City of Fremont
Newaygo County, Michigan
Wastewater Lagoon Improvements

PROJ #2023755002.00

ADDENDUM #1

DATE:07/31/23

Sheet:
G8

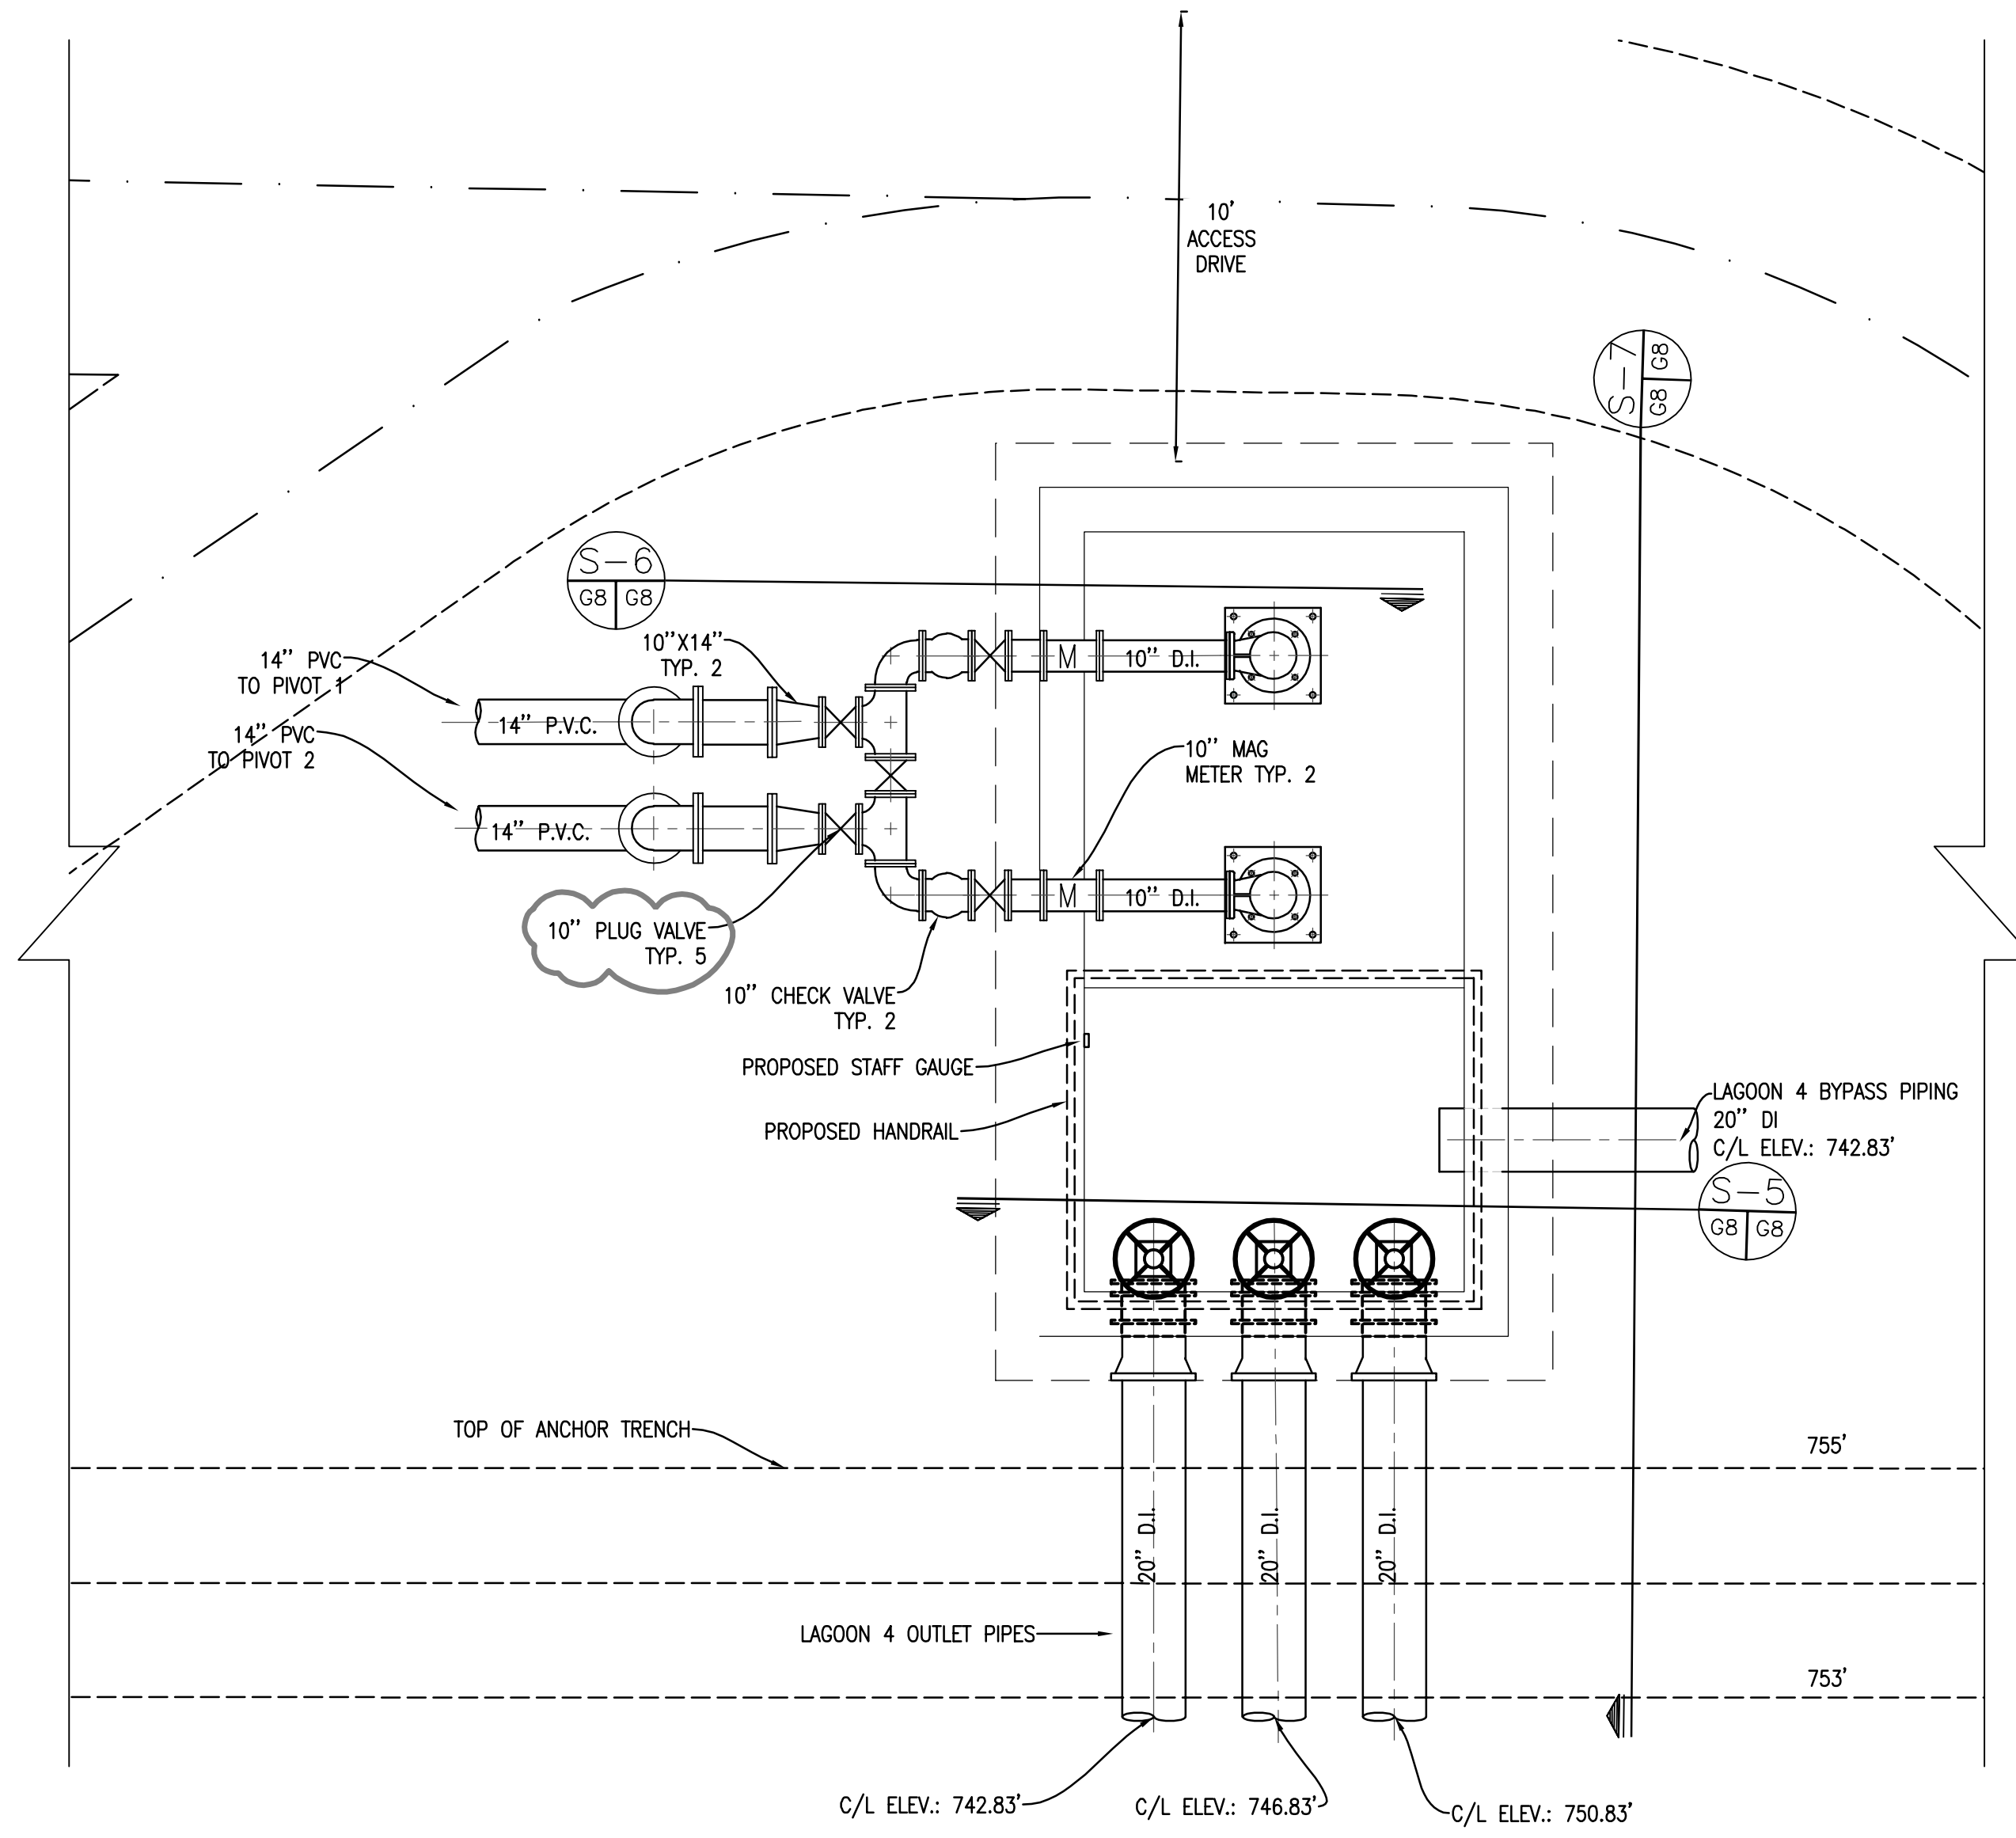
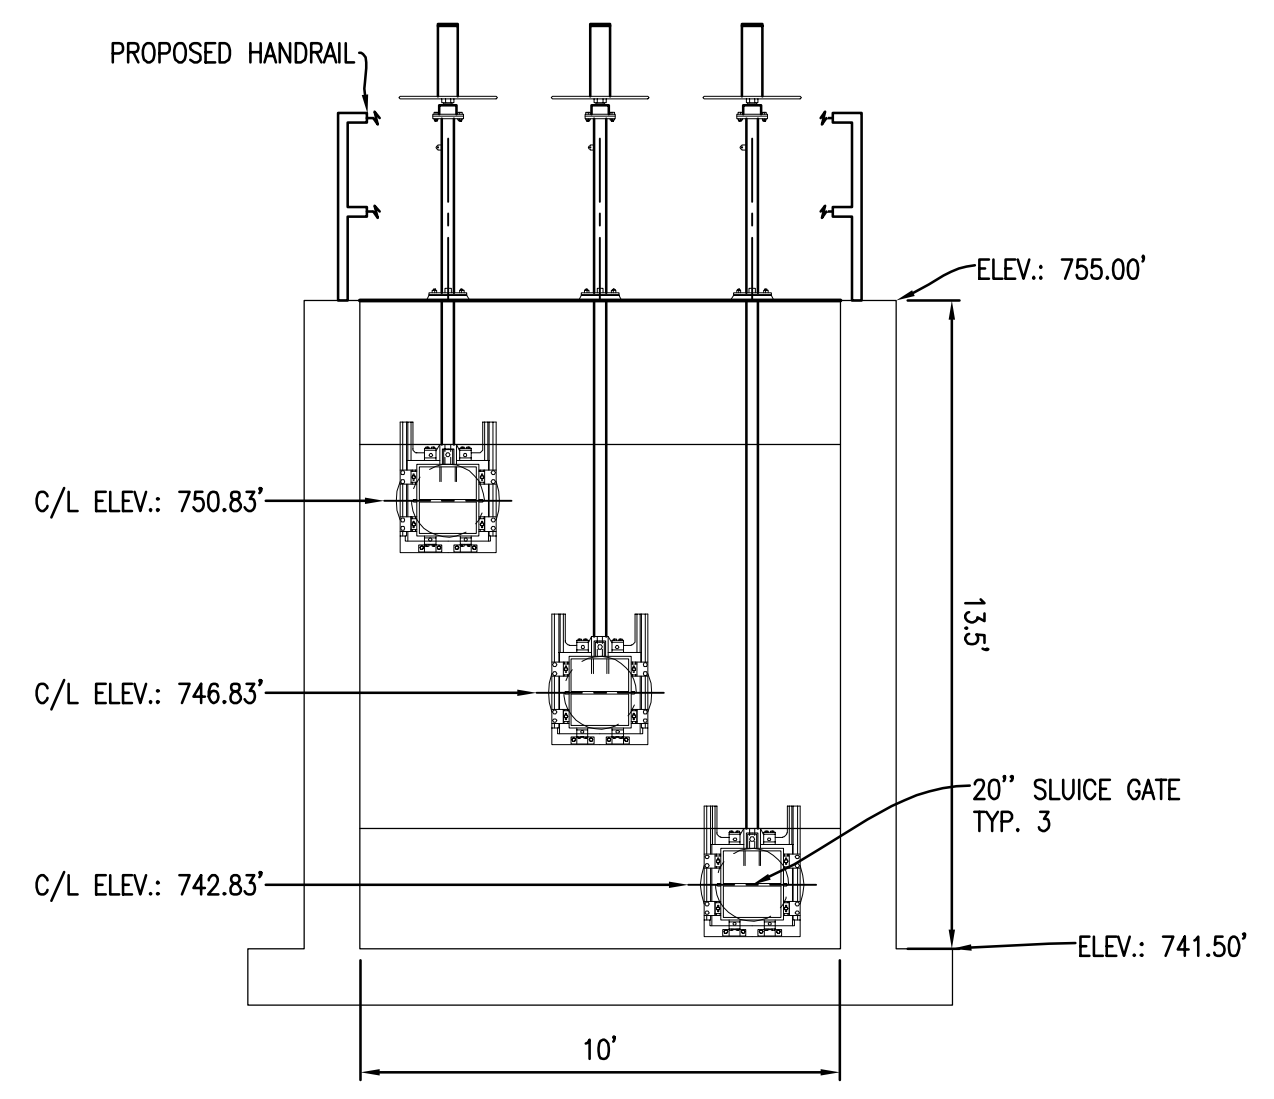
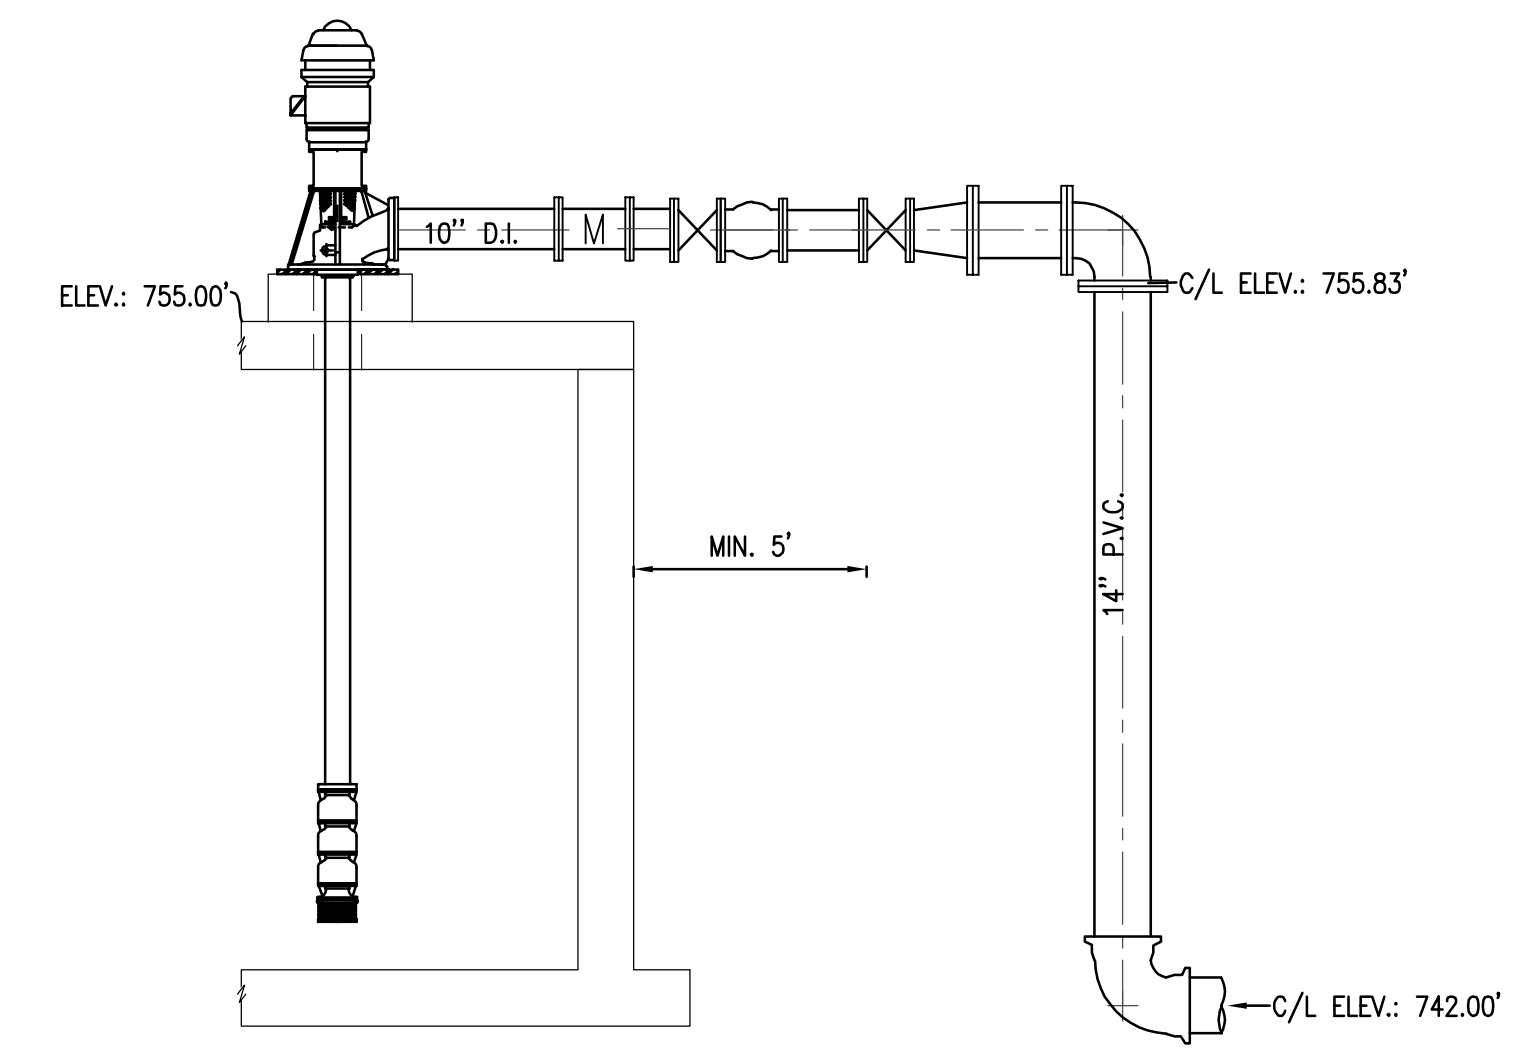
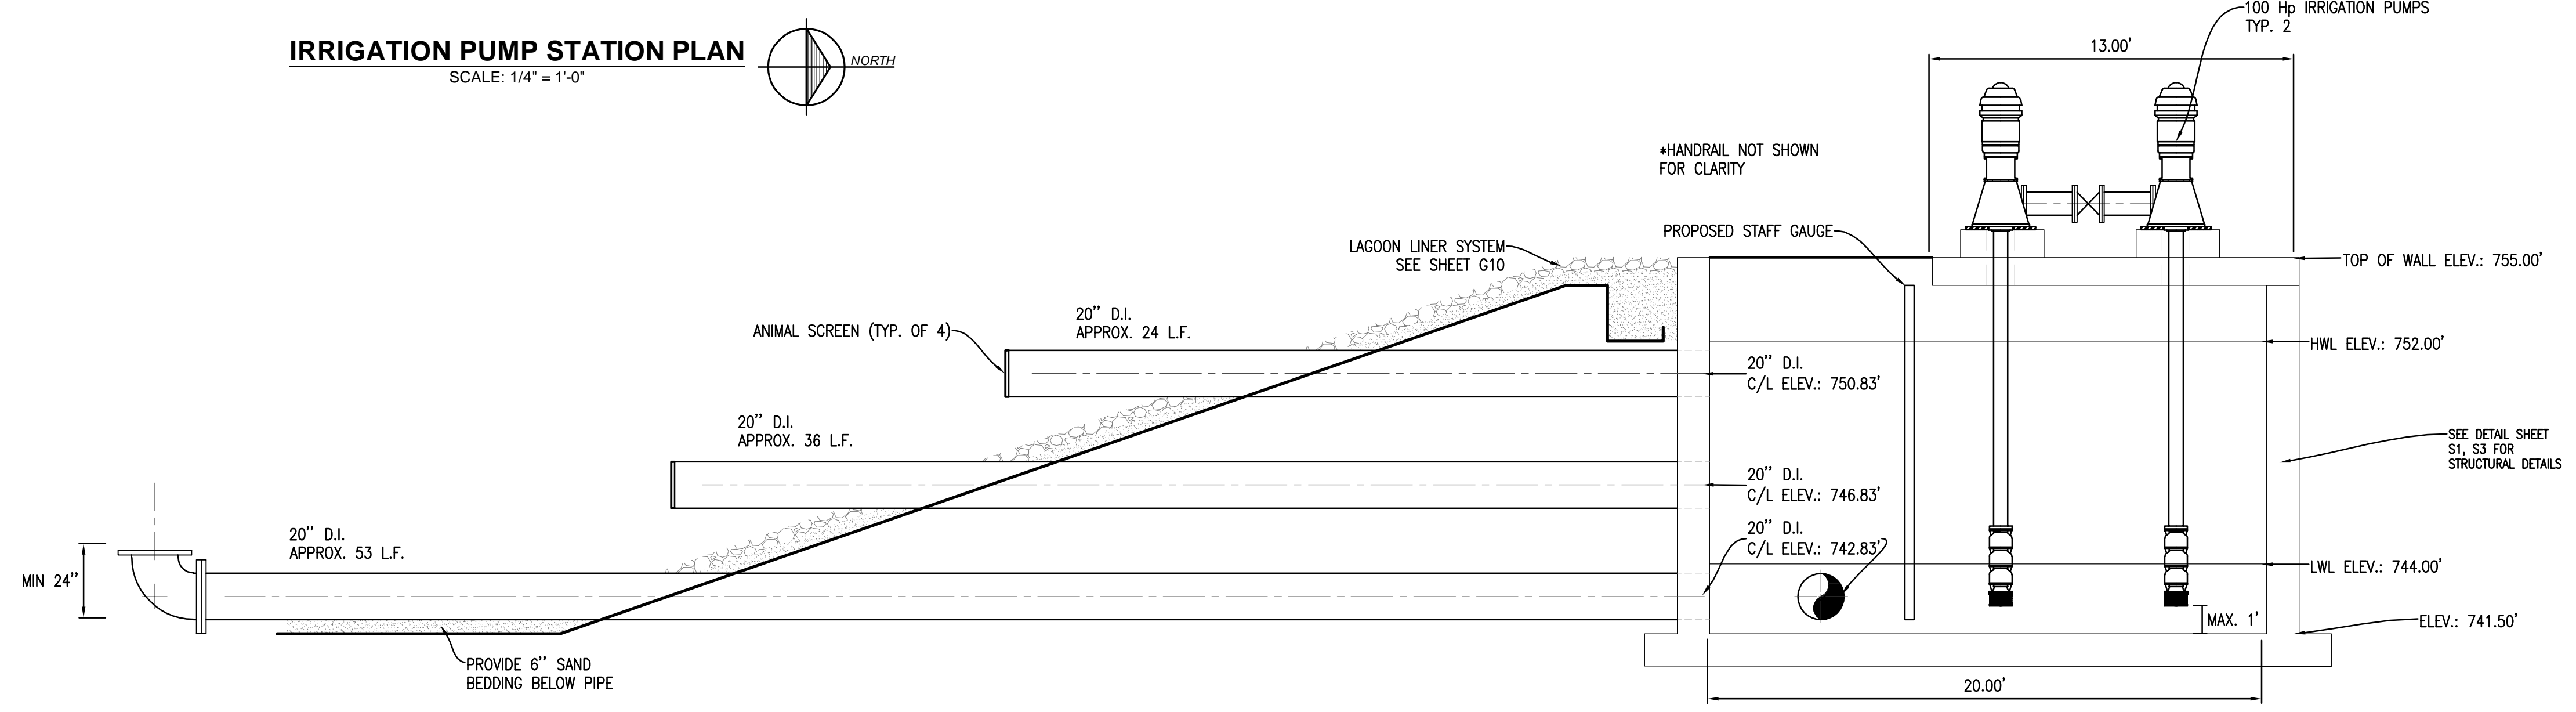
5. Section 400559 / Sheet G8 : can the size of the proposed slide gates at the new irrigation pump station be provided.
Slide gates are called out as 20”

1. **G5: REPLACE** with attached: Lagoon 4 By-passing piping valves to be gate valves with box, lid and telescopic extension stem.
2. **G7: REPLACE** with attached: Replacement of existing sluice gates has been eliminated from the project.
3. **G8: REPLACE** with attached: Irrigation Pump Station Plan: 10” **Ball Plug** Valves
4. **G10: REPLACE** with attached: Overflow pipe to be 20” CPP, Road Gravel to extend over anchor trench to top of basin stone anchor system, in addition to access road as shown on plans. Sand cover to be 12” with 6” stone.

Sheet:
G10

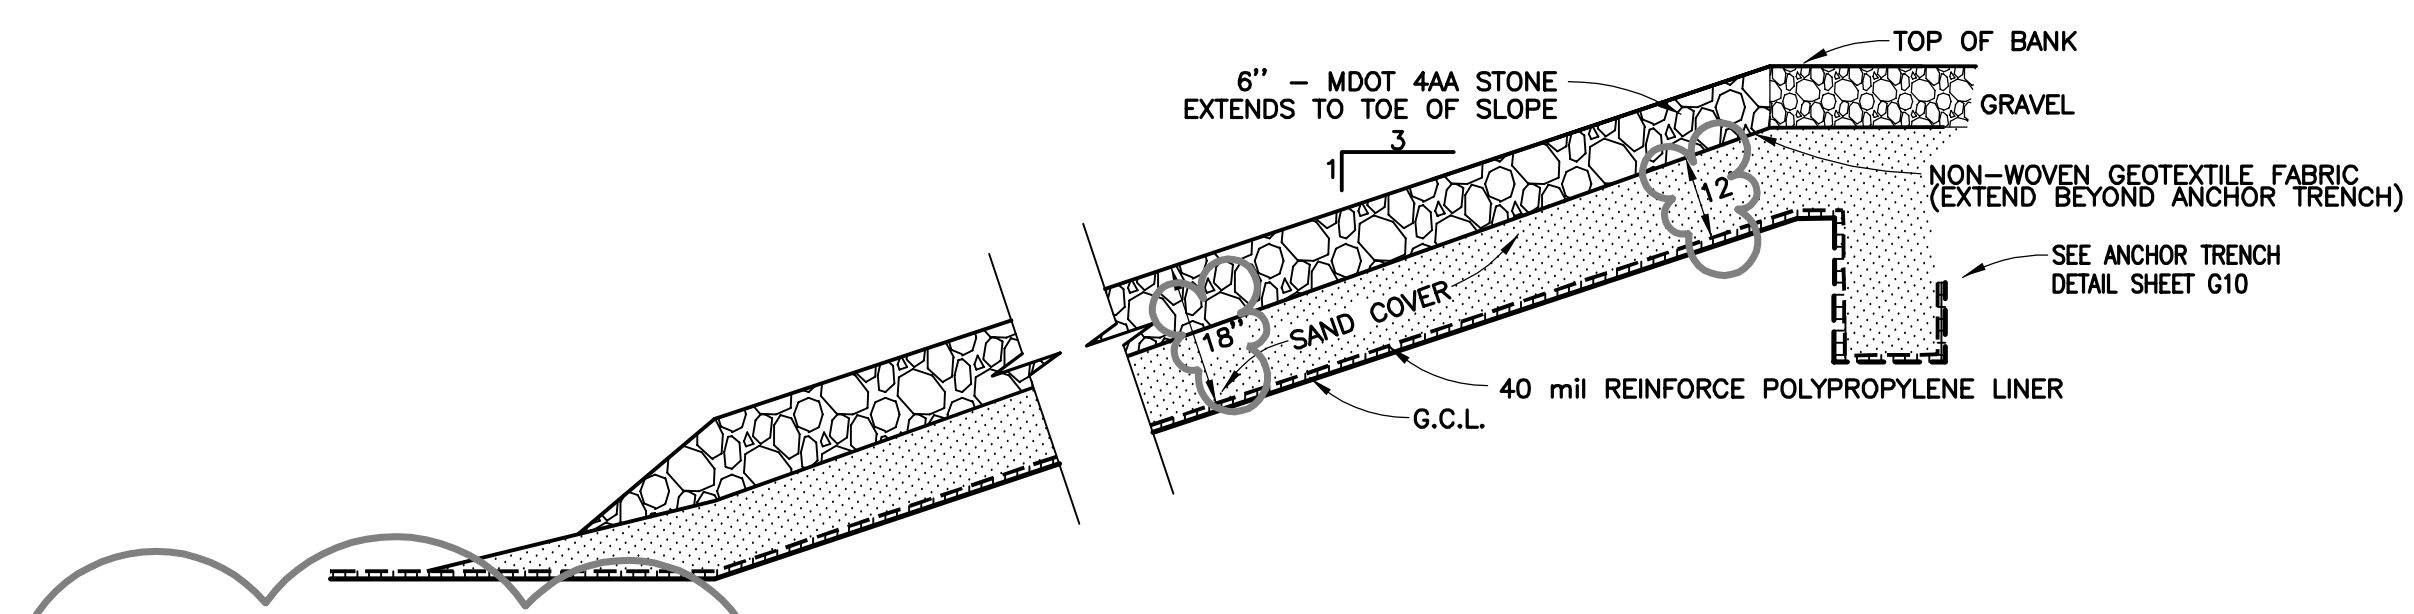
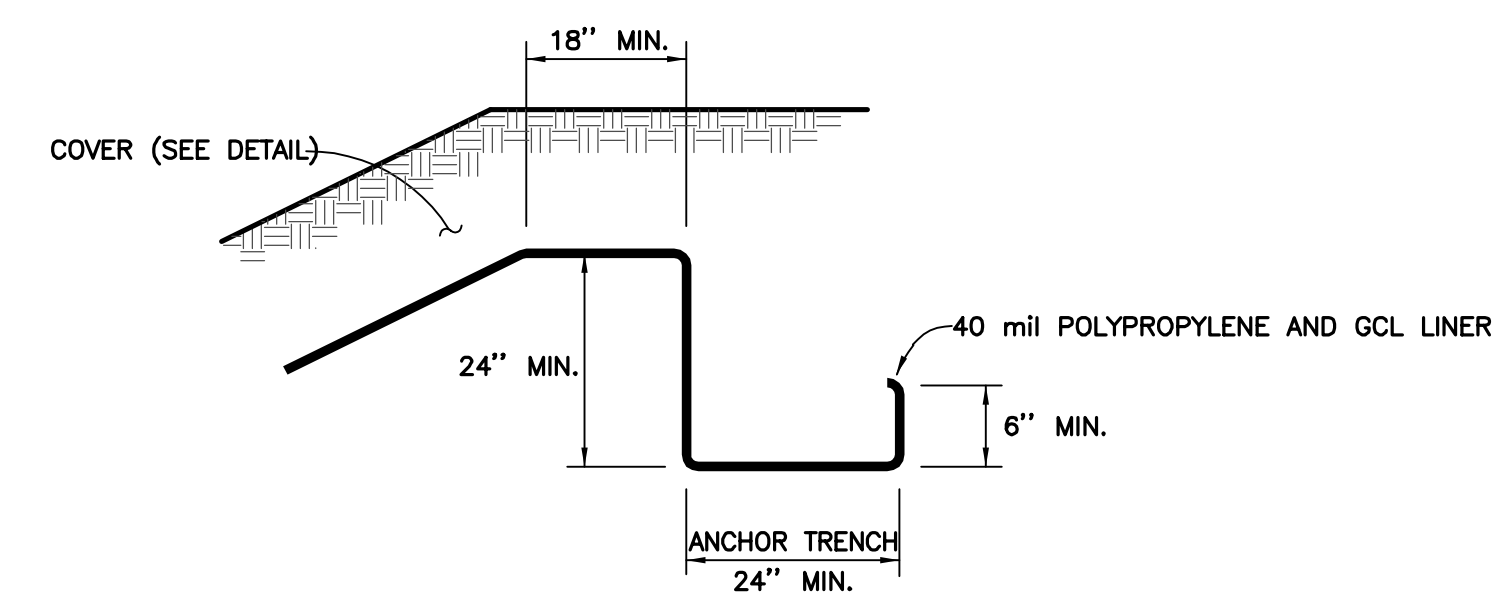
9. Please clarify the detail for the anchor trench and road detail on top of the berm (page G10).
See updated detail sheet G10. Road gravel shall extend to the top of stone armor system in addition to the 10’-12’ wide access drive. Liner shall have anchor trench as shown in detail.
